January 13, 2025

**Re: Lofts at Winrock
7500 Indian School NE
Conceptual Traffic Circulation Layout for DFT Approval
Engineer's Stamp 1-9-25 (J19D089)**

TRAFFIC CONTROL PLAN

TRAFFIC CONTROL PLAN

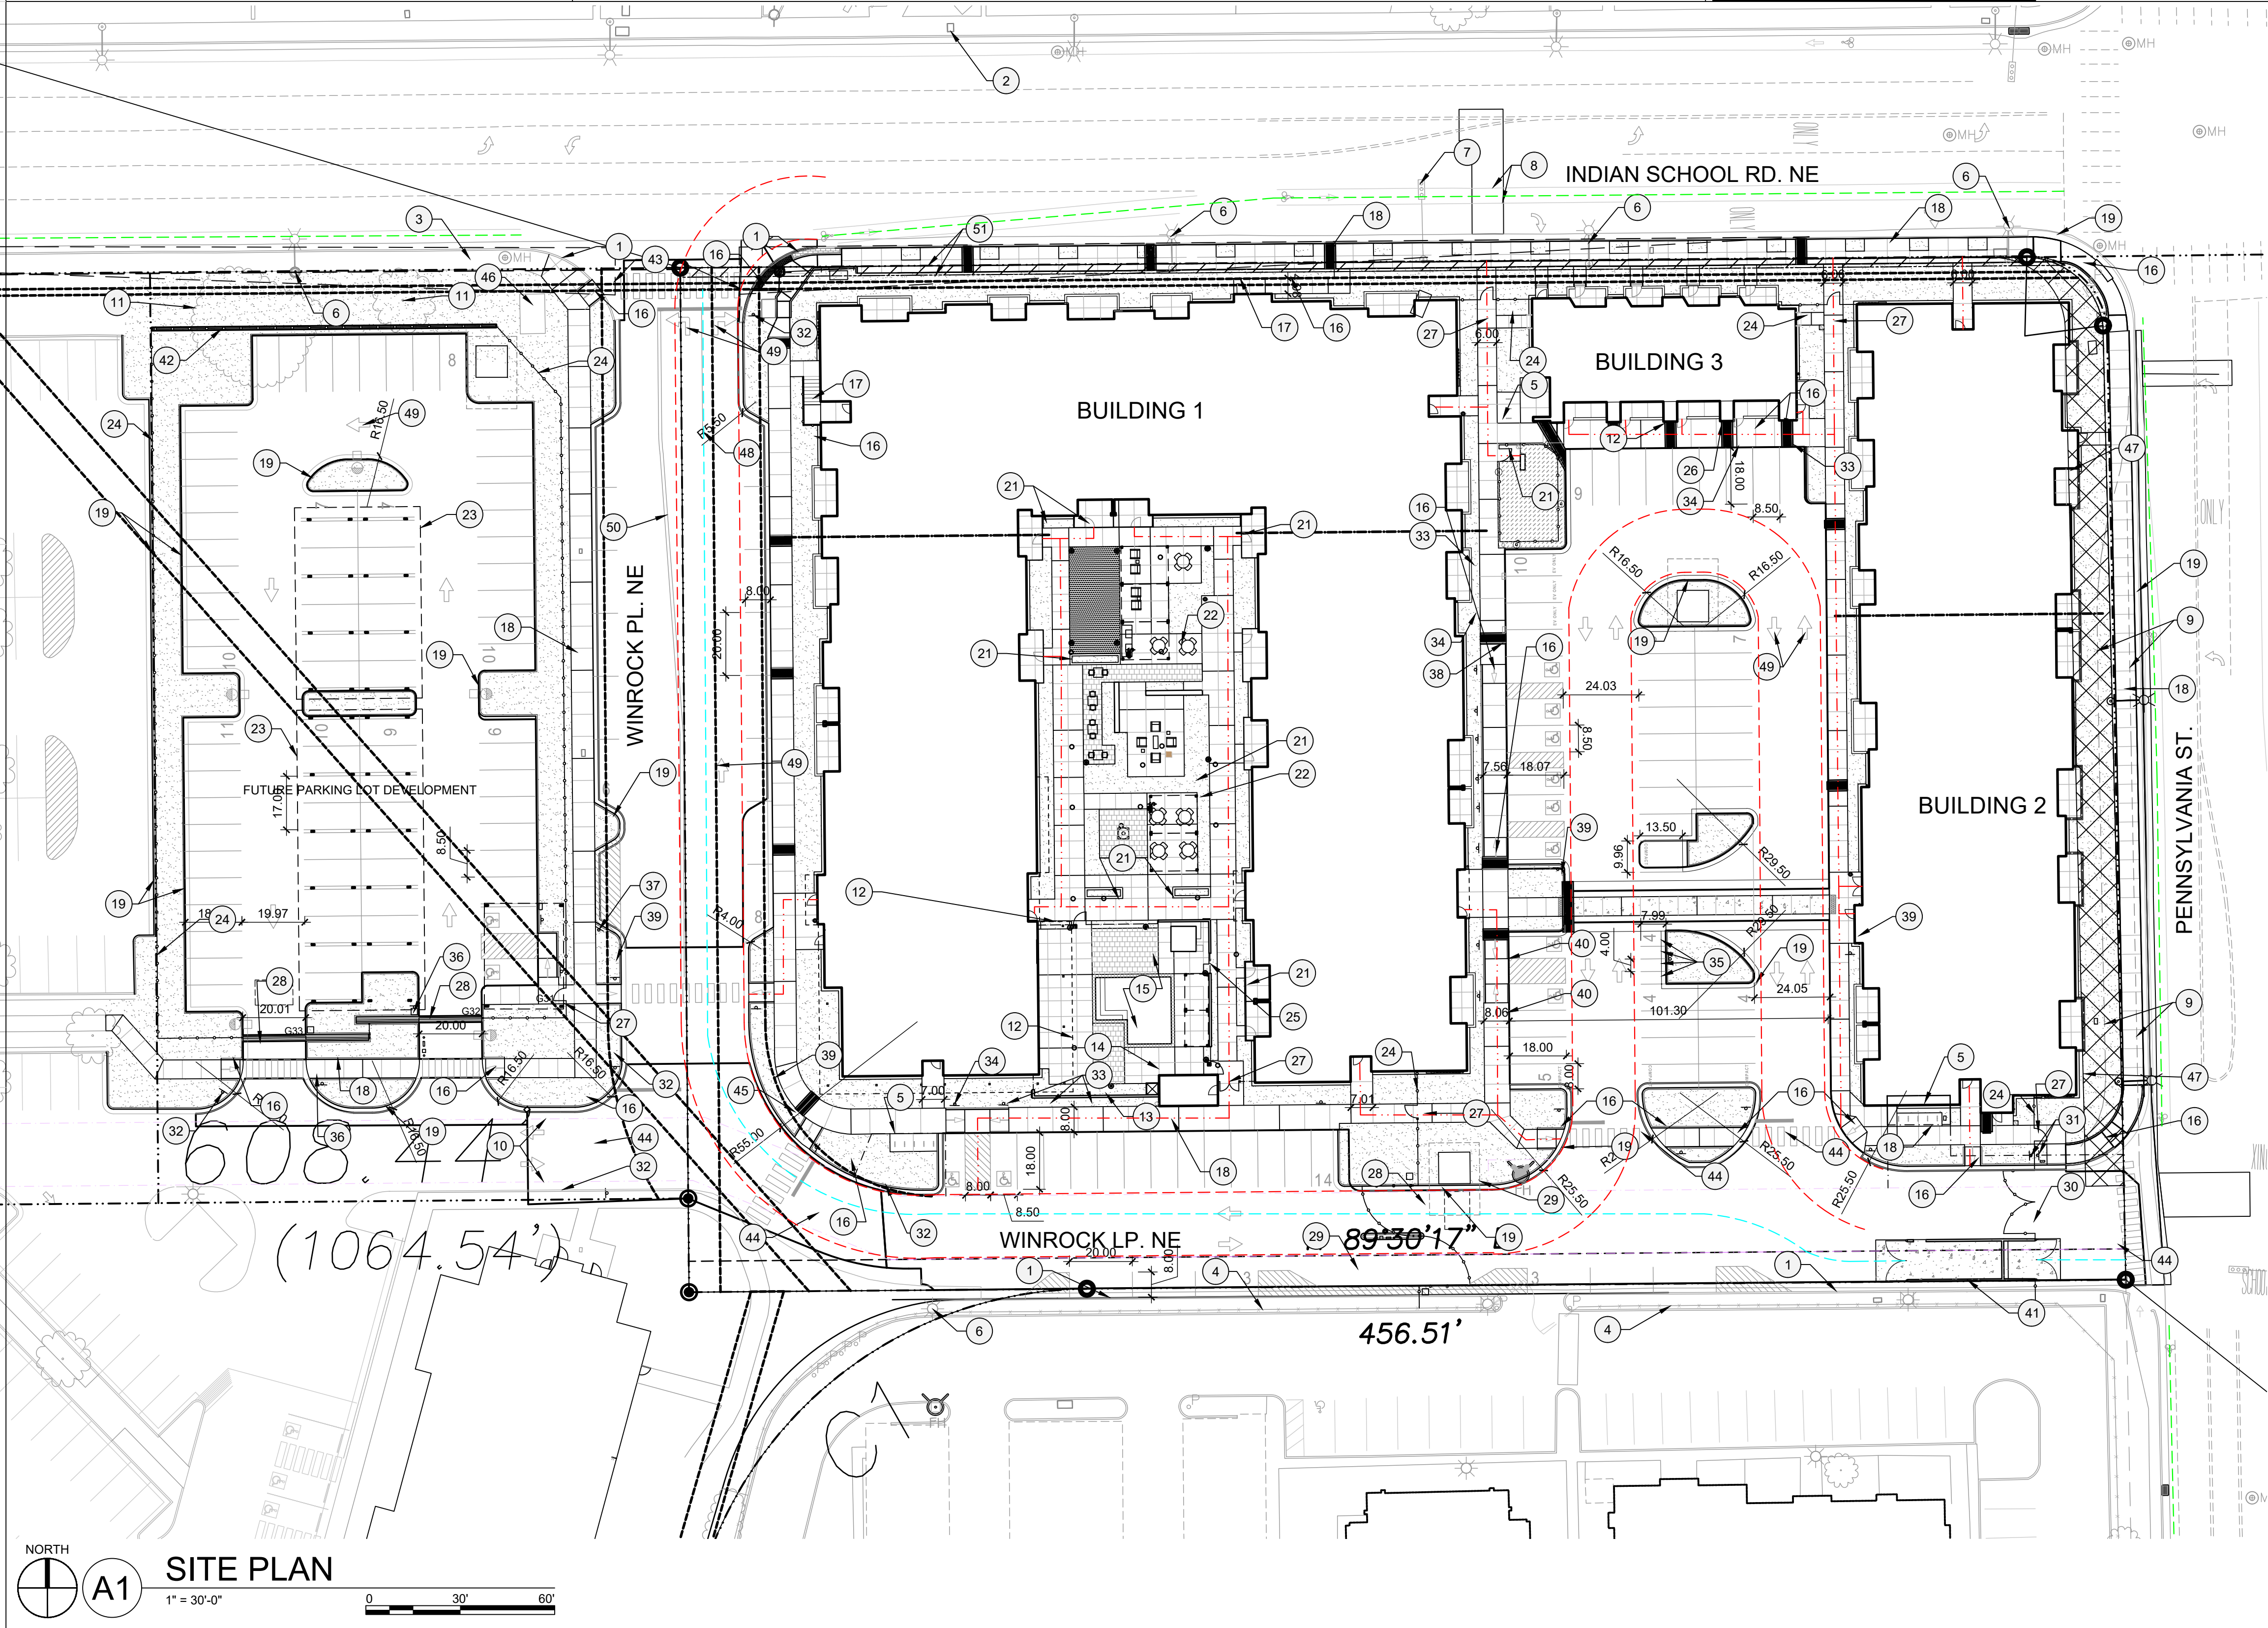
The conceptual TCL submittal received 1-10-2025 is approved for DHO and/or DFT submittal. When submitting this project through the building permit process, a full Traffic Circulation Layout will need to be submitted and approved prior to building permit. **When submitting TCL for building permit approval, please ensure:**

- 1- that both site access details are provided and updated to meet the current ADA city standard.**
- 2- A signed copy of TSF included**
- 3- Fire and solid waste approvals are included**
